<b>DART AEROSPACE LTD</b>		<b>Work Order:</b>	120863
<b>Description: Crosstube Assembly</b>		<b>Part Number:</b>	D206-667-241
<b>Inspection Dwg: D206-667-241 Rev: C</b>		<b>Page 1 of 2</b>

DRAWING NO. D206-667-241	TITLE CROSSTUBE ASS'Y (206B HIGH AFT)	REV. C	<b>DART AEROSPACE LTD ENGINEERING ORDER</b>		D.E.O. NO. D206-667-241-C-1	SHEET NO. SHEET 1 OF 1	SCALE NTS
DRAWN <i>qp</i>	CHECKED <i>AS</i>	MFG. APPR. <i>M</i>	APPROVED <i>WD</i>		DE APPR. <i>H</i>		
DATE 11.07.15	DATE 11.08.22	DATE 11.08.22	DATE 11/08/22		DATE 11.08.22

**PURPOSE:**

REPLACE MAGNOBOND WITH PROSEAL.

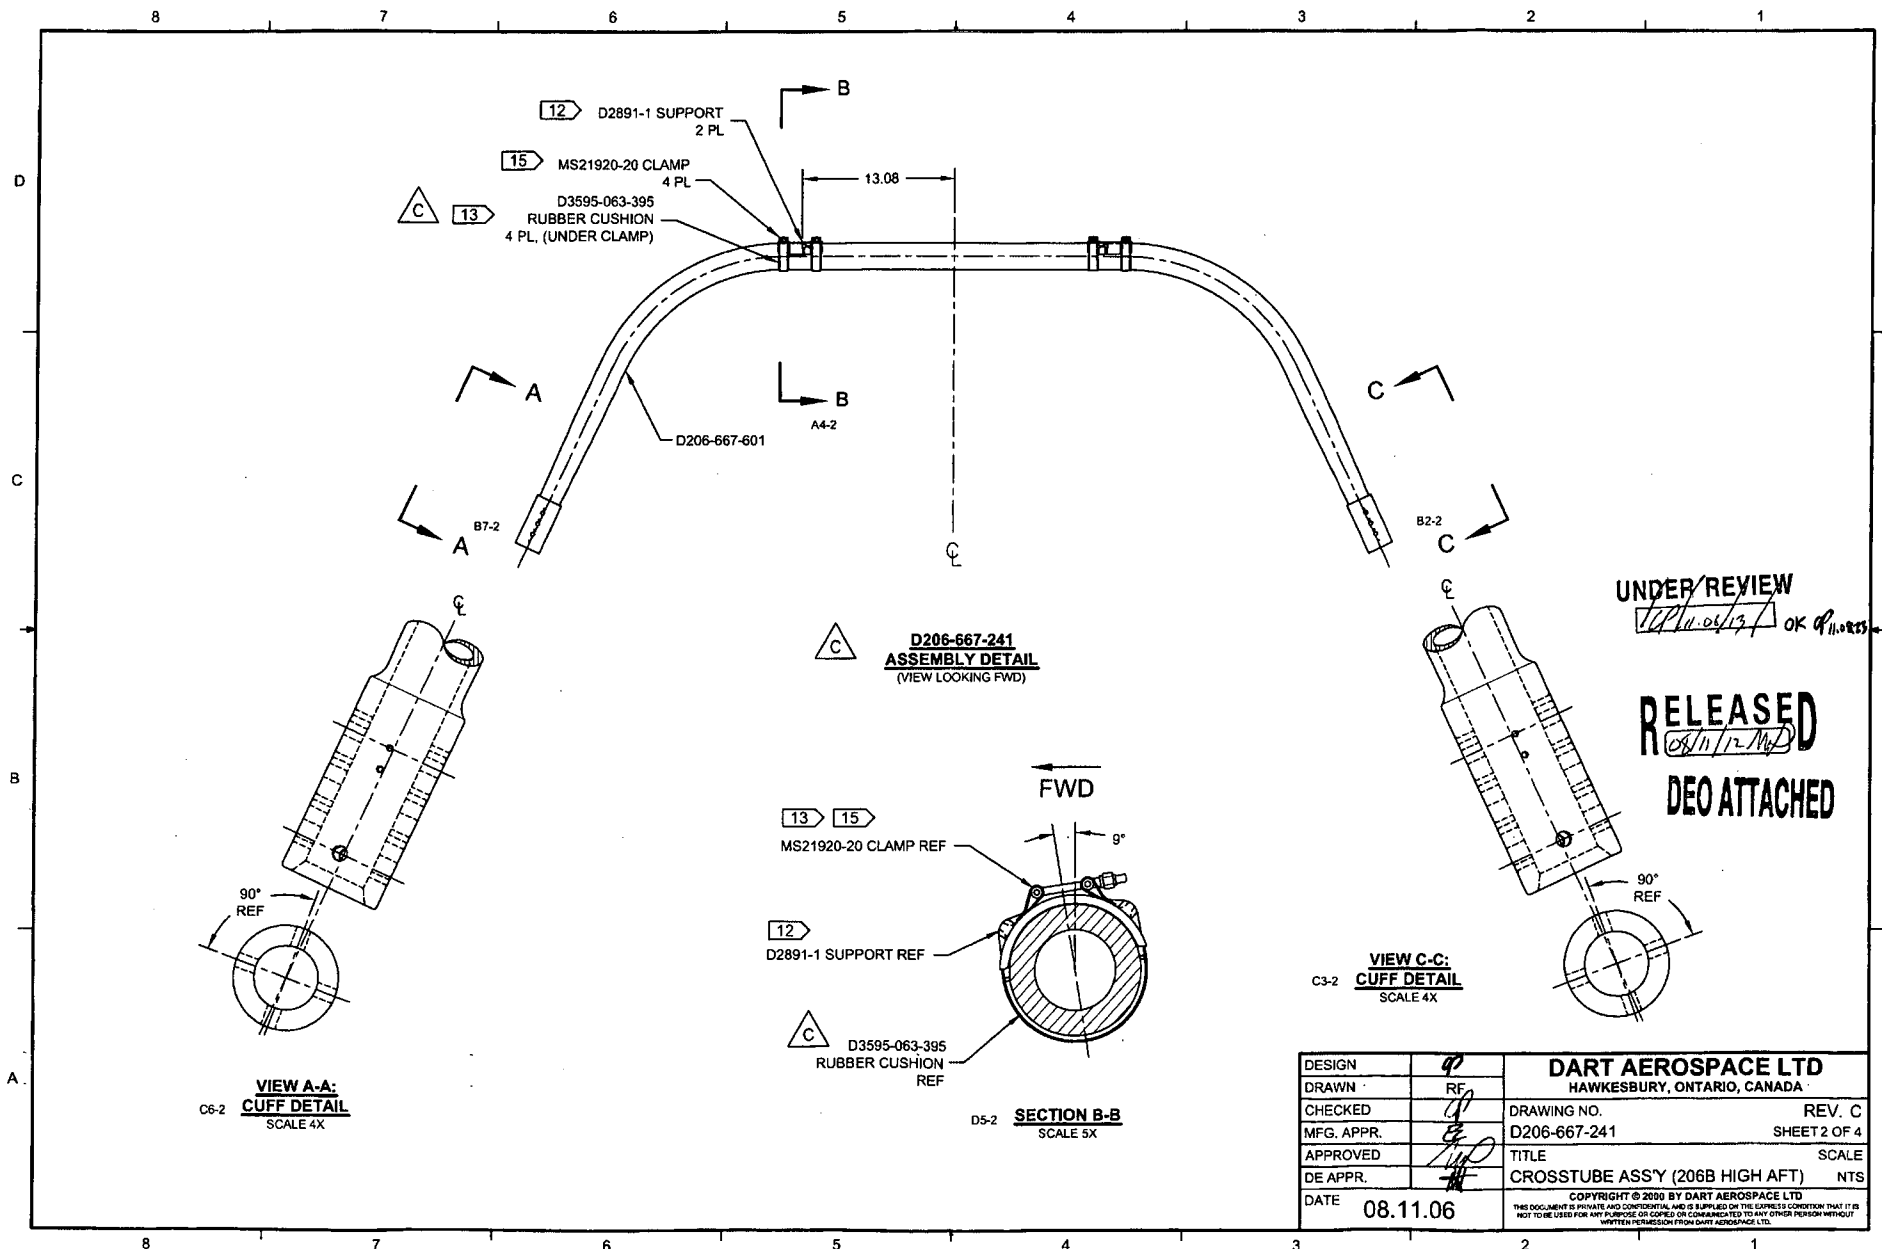
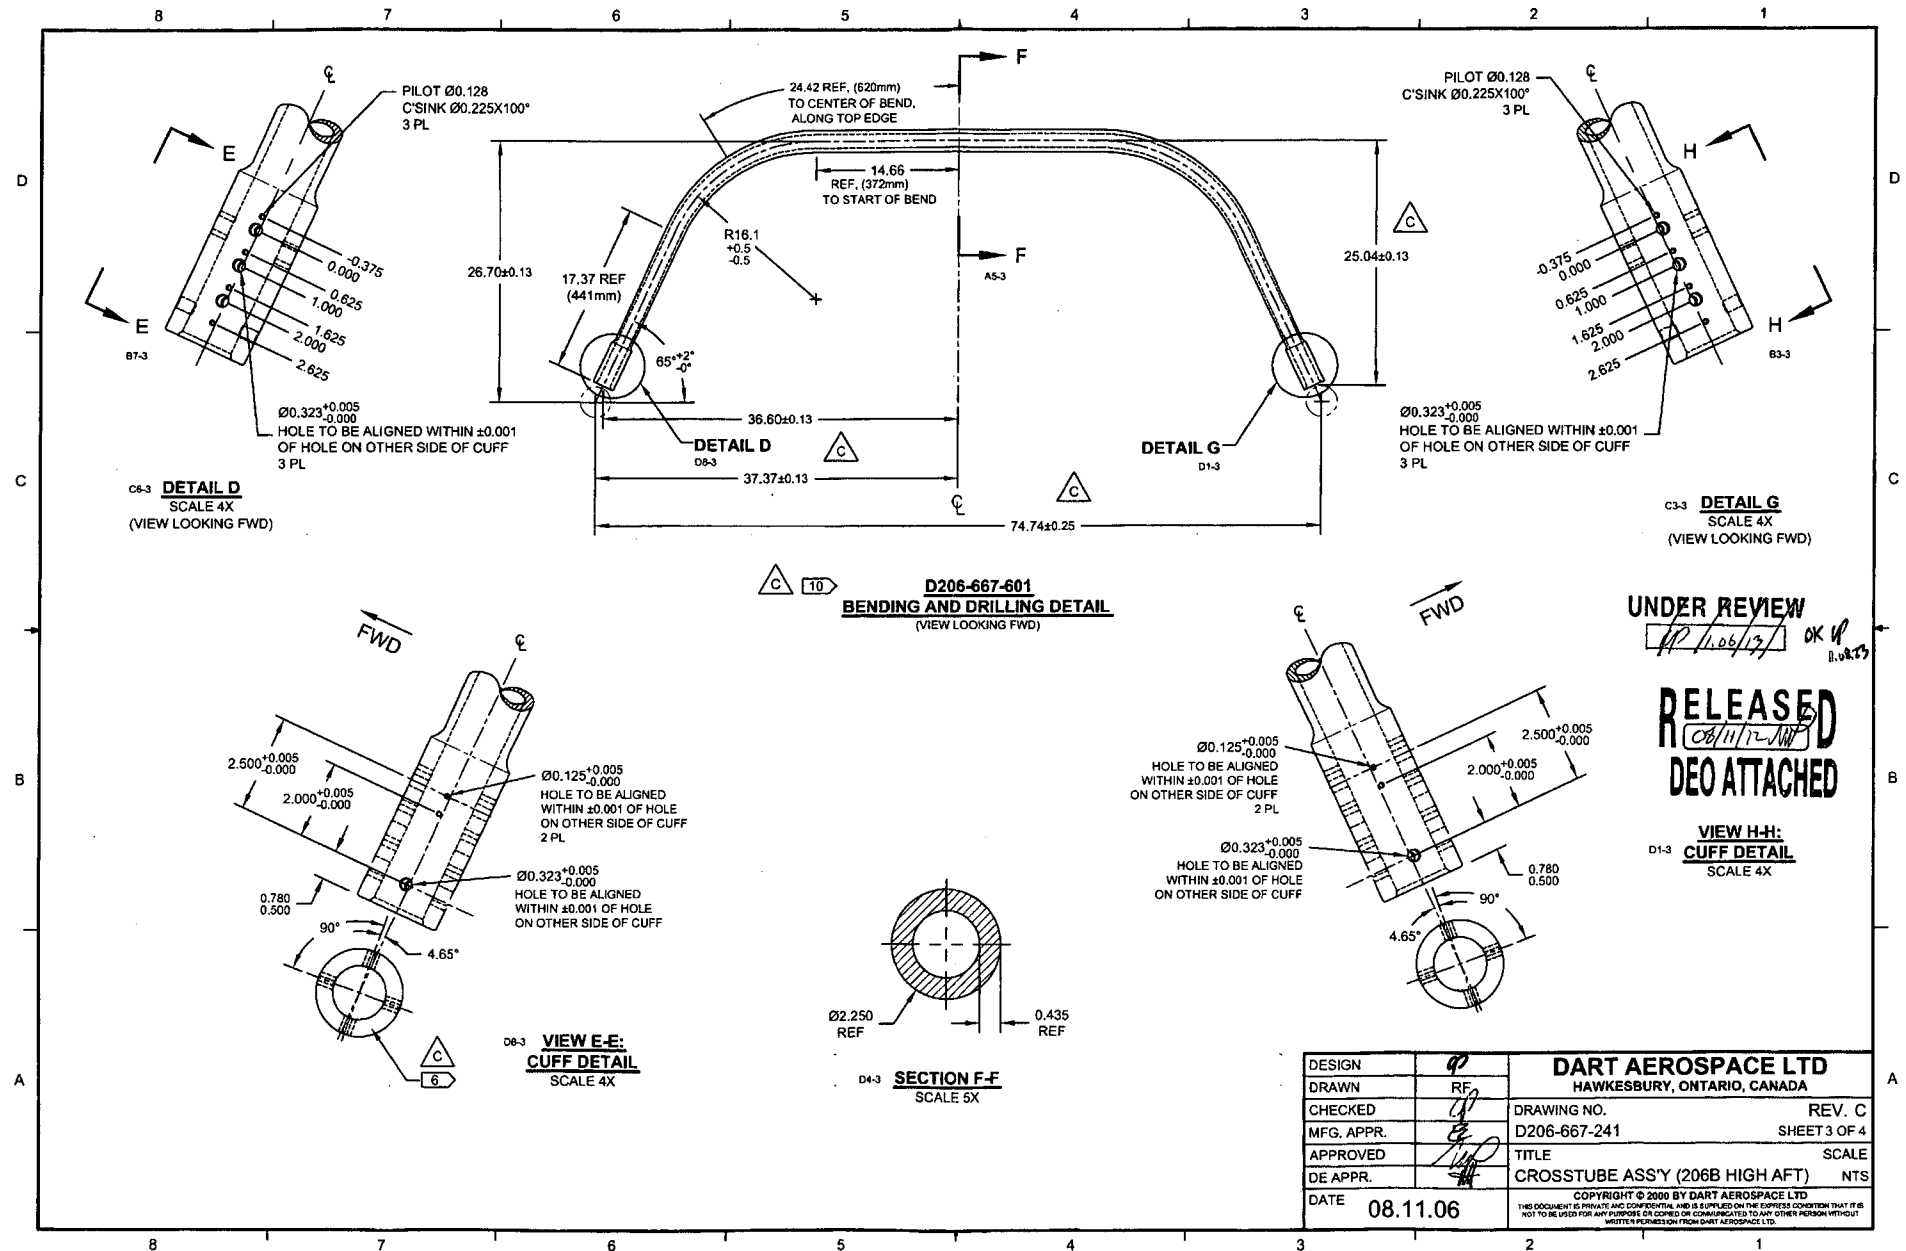
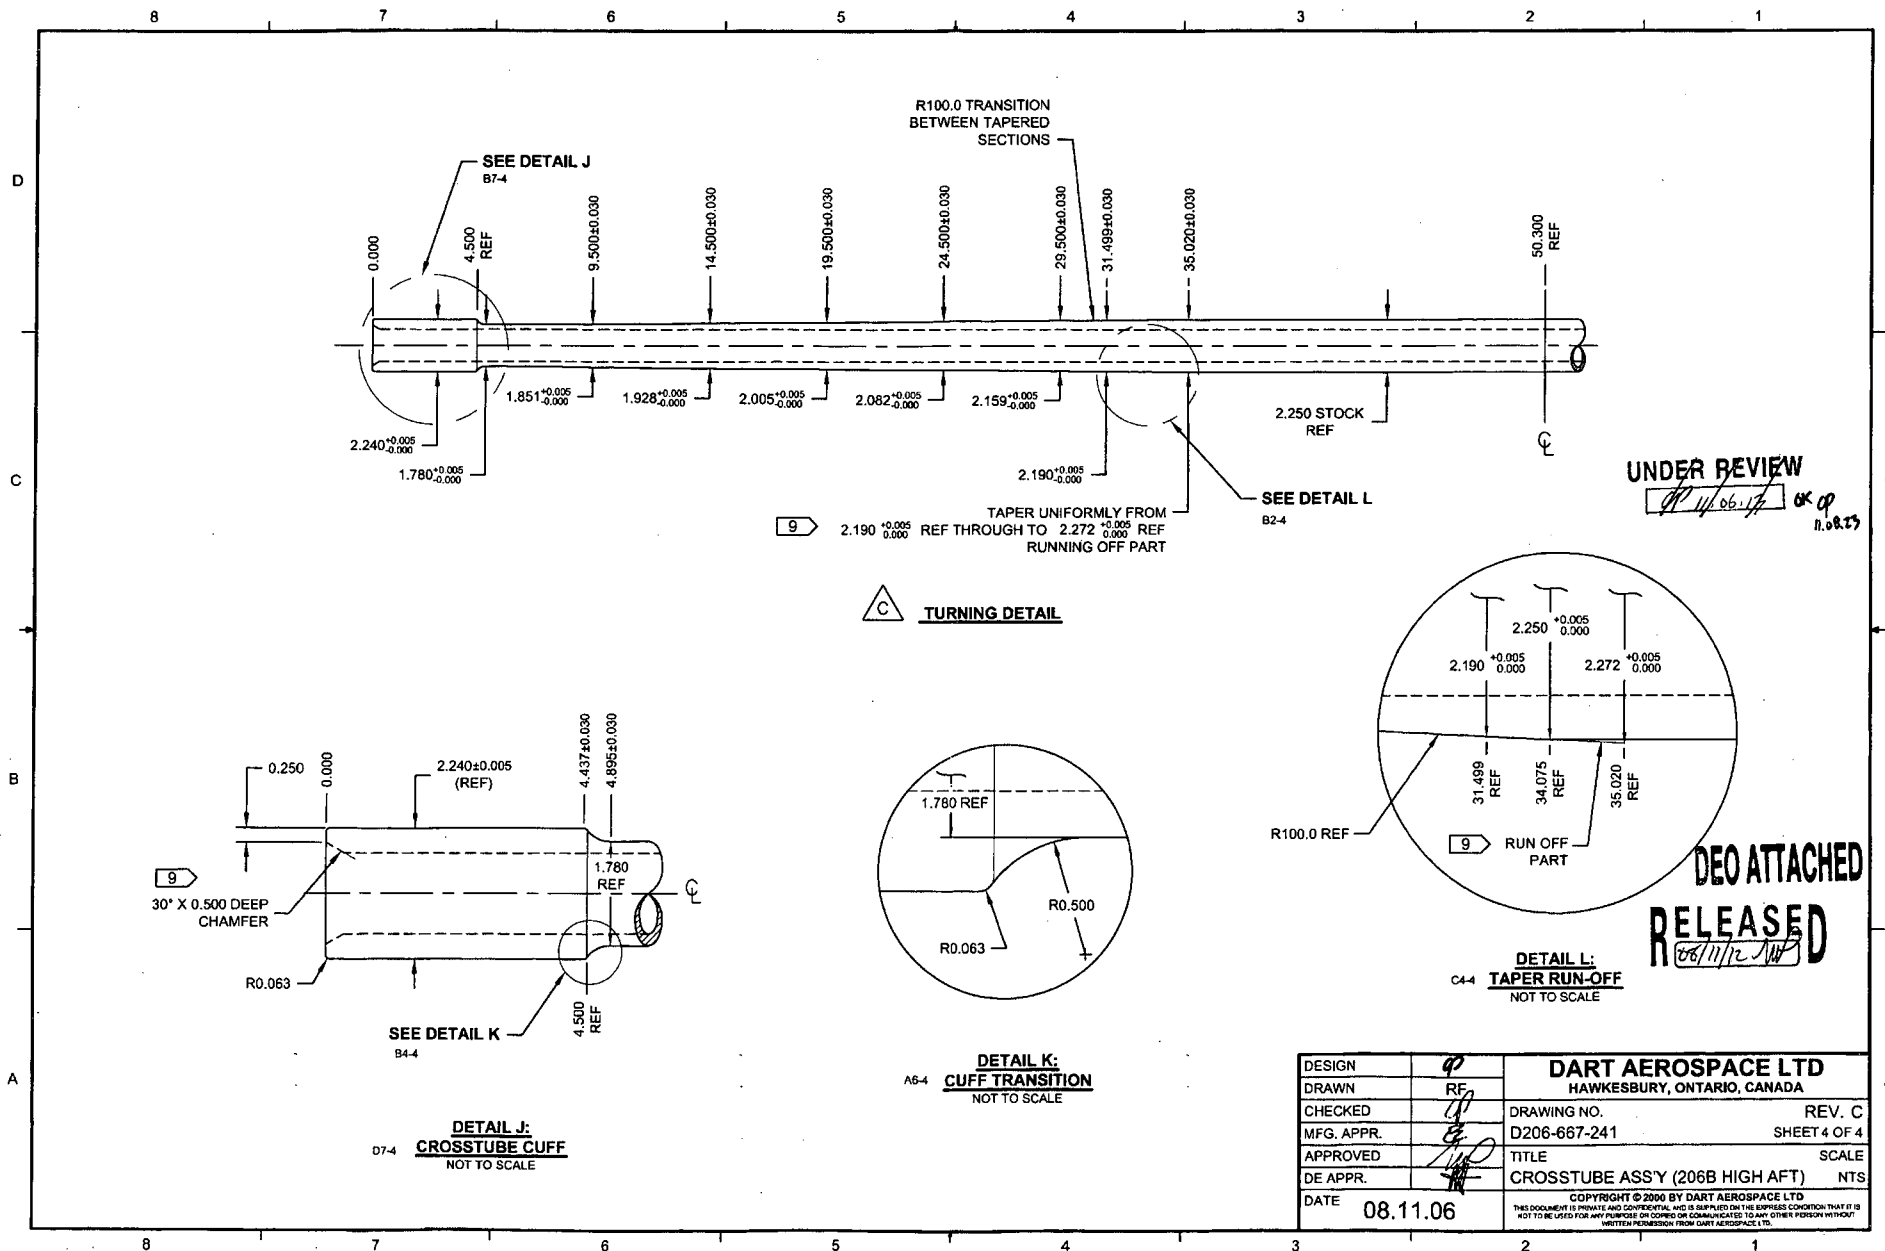
C	REFORMAT/REVISE GENERAL NOTES/PART LIST (ZN D7-1); REORGANIZED VIEWS AND REFORMATTED DRAWING TO CURRENT STANDARDS. D3595-063-395 WAS D2856-400-694 (ZN D8-2 & A5-2); REMOVED REF. & ADD TOLERANCES (ZN C5-3, C4-3, D3-3); RELOCATED FLAG #6 (ZN A7-3) PER NCR 210; MOVED TURNING DETAIL & UPDATED TOLERANCE TO SHEET 4.	RF	08.11.06
B	ADD HOLES FOR COMPATABILITY WITH BHT/AA SKIDTUBES	PH	05.02.04
A	NEW ISSUE	CP	00.11.17
REV.	DESCRIPTION	BY	DATE
DESIGN	RF	DART AEROSPACE LTD HAWKESBURY, ONTARIO, CANADA	
DRAWN	RF	DRAWING NO.	REV. C
CHECKED	RF	D206-667-241	SHEET 1 OF 4
MFG. APPR.	RF	TITLE	SCALE
APPROVED	RF	CROSSTUBE ASS'Y (206B HIGH AFT)	NTS
DE APPR.	RF	COPYRIGHT © 2000 BY DART AEROSPACE LTD THIS DOCUMENT IS PRIVATE AND CONFIDENTIAL AND IS SUPPLIED ON THE EXPRESS CONDITION THAT IT IS NOT TO BE USED FOR ANY PURPOSE OR COPIED OR COMMUNICATED TO ANY OTHER PERSON WITHOUT WRITTEN PERMISSION FROM DART AEROSPACE LTD.
